VIII. Fuse Plug Design, Construction and Activation

A. Fuse Plug Design.

The MWH Design Report dated March 2002 provided design data for the Silver Lake fuse plug. Items of design data were extracted from the Design Report for presentation and discussion in this Section. Applicable comments and findings are incorporated with the design items

UPPER PENINSULA POWER COMPANY
 THE PROJECT IS THE RESPONSIBILITY OF THE ENGINEER
FUSE PLUG SPILLWAY & DAM IMPROVEMENTS
FUSE PLUG AND SPILLWAY CHANNEL
PLAN AND PROFILE

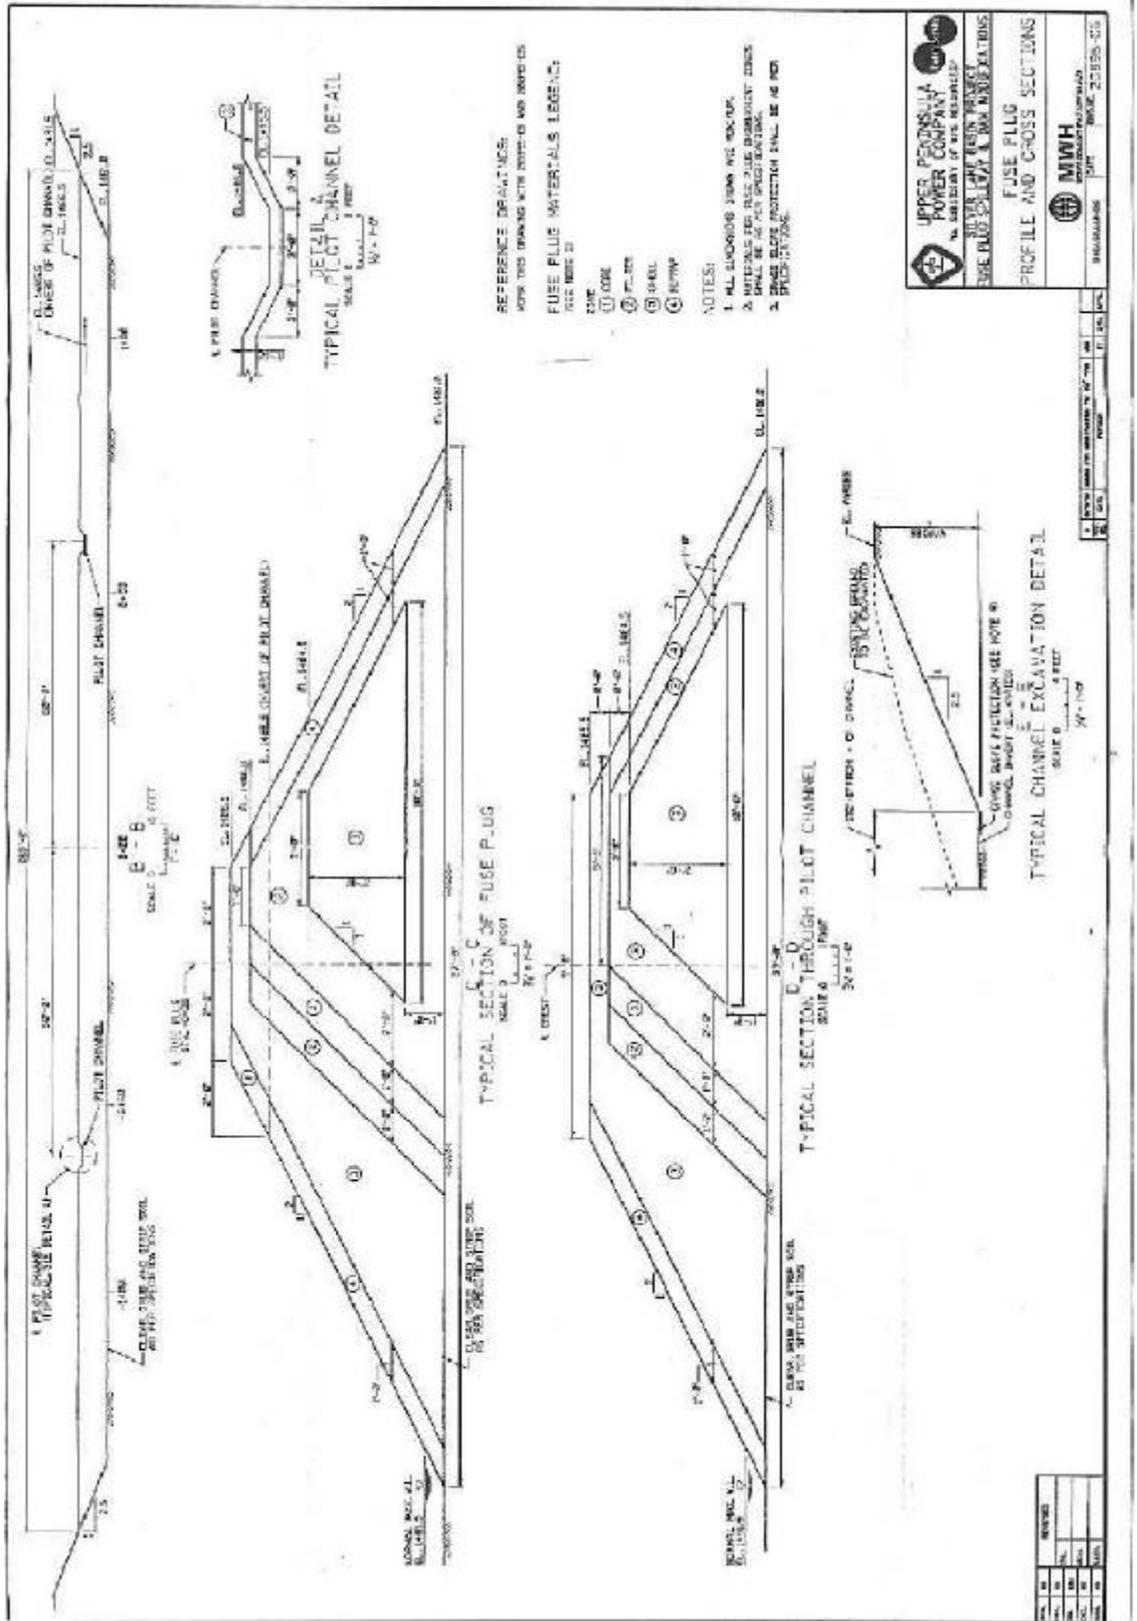
As noted on the design and as-built fuse plug cross section and pilot channel cross section drawings, the top of the design fuse plug is elevation 1486.5 feet and the pilot channel elevation is 1485.5 feet respectively. As-constructed survey of the fuse plug dike indicates the two pilot channels to have invert elevations of 1,485.37 and 1,485.28 feet, approximately 1.5 to 2.6 inches below the design elevation of 1,485.5 feet. When these fuse plug elevations are compared to the elevation of the concrete ogee spillway crest elevation of 1486.25 feet, it becomes obvious that the concrete ogee spillway will no longer be the primary spillway. The fact the fuse plug will erode before the reservoir reaches the concrete ogee spillway crest elevation of 1486.25 feet was not discussed in the Design Report or pointed out in any other documentation that we have found. The design and as-built fuse plug cross sections and pilot channel cross sections indicate that the normal maximum water level will be 1481.5 feet. This elevation is also stated in Section 5.3 Reservoir Level, "The initial water level prior to the PMF event is at the normal maximum operating reservoir level of El. 1481.5 feet." The consultant apparently did not revised the plans and design documents to show that the normal maximum operating level was changed to El. 1482.5 feet per his letter dated September 24, 2001, which was enclosed with the licensee's September 27, 2001 letter to FERC.

When the designer representative was asked why the fuse plug was designed with a pilot channel elevation that is 0.75 feet lower than the concrete ogee spillway crest, he stated that it was not intended for the concrete ogee spillway to operate as the primary spillway after the fuse plug was installed. The designer representative stated that the primary capacity to pass lower floods would be handled by the outlet works, the slot in the fourth bay of the concrete ogee spillway (with stop logs at 1482.5 feet), and the storage volume from the lower reservoir operating level of 1481.5 feet. The outlet works and slot in the fourth bay of the concrete ogee spillway could be expected to pass approximately 634 cfs before the fuse plug would activate. The designer representative indicated that it should take greater than a 1 in 500 years event to activate the fuse plug with this design.

While the stated normal maximum operating level of 1481.5 feet is given in several places in the Design Report, the required lower operating level does not appear to have been discussed by the designer with the Licensee. In our discussions with Licensee personnel, the responses were that the designer did not discuss a requirement to operate the reservoir at a maximum normal level of 1481.5 feet. When the designer's representative was asked if the lower operating pool level requirement was discussed with the Licensee, the response was that the information is in the Design Report and the Licensee reads everything before it is sent forward.
